Item Name: Heli-Utility-Basket™ - RH

DART SERVICE INSTRUCTION

TO AMEND INSTALLATION INSTRUCTIONS D205-541 REV. J AND
INSTRUCTIONS FOR CONTINUED AIRWORTHINESS ICA-D205-541 REV. 4

A	NEW ISSUE	DW	14.11.27
REV.	DESCRIPTION	BY	DATE
DESIGN	DW	DART AEROSPACE LTD HAWKESBURY, ONTARIO, CANADA	
DRAWN	DW		
CHECKED	AP	DRAWING NO.	REV. A
MFG. APPR.	N/A	DSI 9667	SHEET 1 OF 2
APPROVED		TITLE	SCALE
DE APPR.		WASHER ADDITION	NTS
DATE	14.11.27	COPYRIGHT © 2014 BY DART AEROSPACE LTD THIS DOCUMENT IS PRIVATE AND CONFIDENTIAL AND IS SUPPLIED ON THE EXPRESS CONDITION THAT IT IS NOT TO BE USED FOR ANY PURPOSE OR COPIED OR COMMUNICATED TO ANY OTHER PERSON WITHOUT WRITTEN PERMISSION FROM DART AEROSPACE LTD.

FIGURE 1

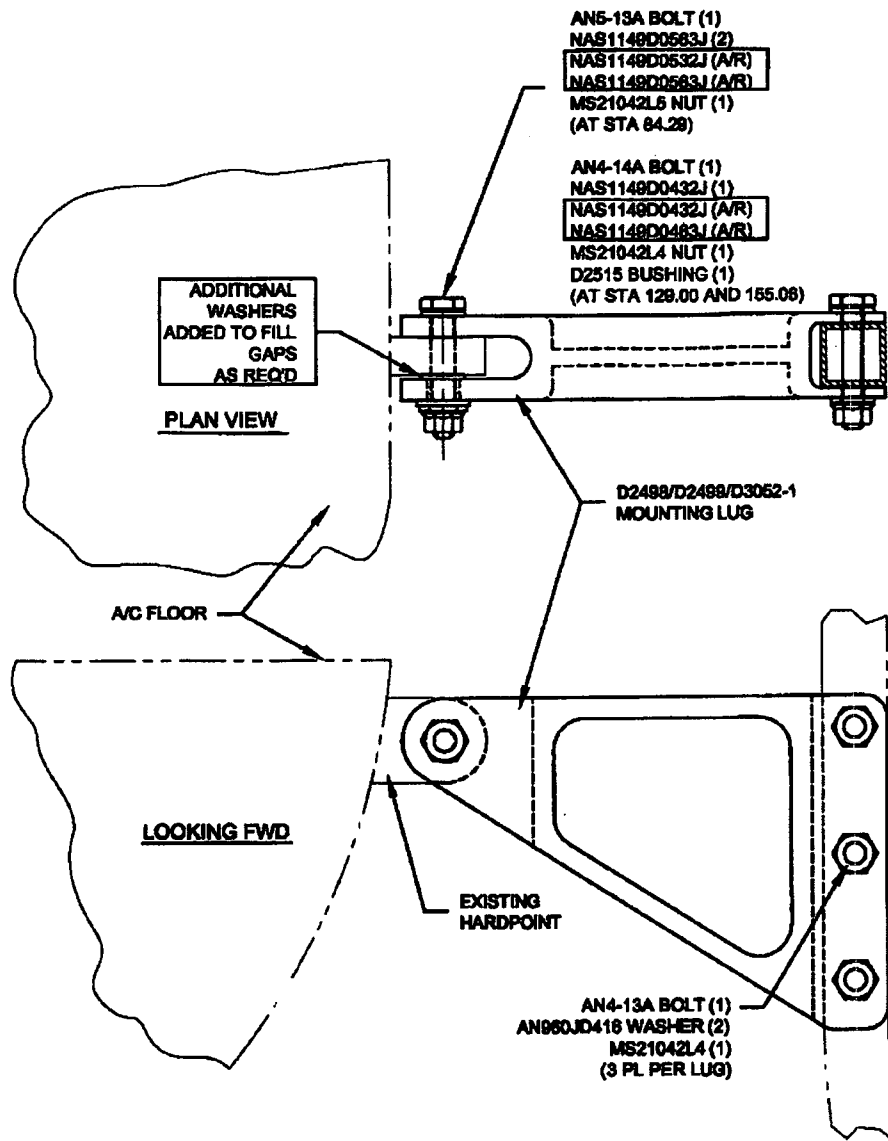
FOR CUSTOMERS/OPERATORS CONCERNED WITH GAPS AT STA's 84.29, 129.00 AND 155.06 WHILE INSTALLING D205-541-043/-044/-045/-046 BASKETS, IT IS ACCEPTABLE TO FILL THE GAPS WITH WASHERS TO REDUCE UNNECESSARY STRESS ON THE MOUNTING LUGS.

INSTALL THE D205-541-043/-044/-045/-046 BASKET KITS PER INSTALLATION INSTRUCTIONS D205-541 WITH ADDITIONAL WASHERS AS SHOWN IN FIGURE 1 OF THIS SERVICE INSTRUCTION.

4	4	4	4	NAS1149D0463J	WASHER
4	4	4	4	NAS1149D0432J	WASHER
2	2	2	2	NAS1149D0532J	WASHER
2	2	2	2	NAS1149D0563J	WASHER
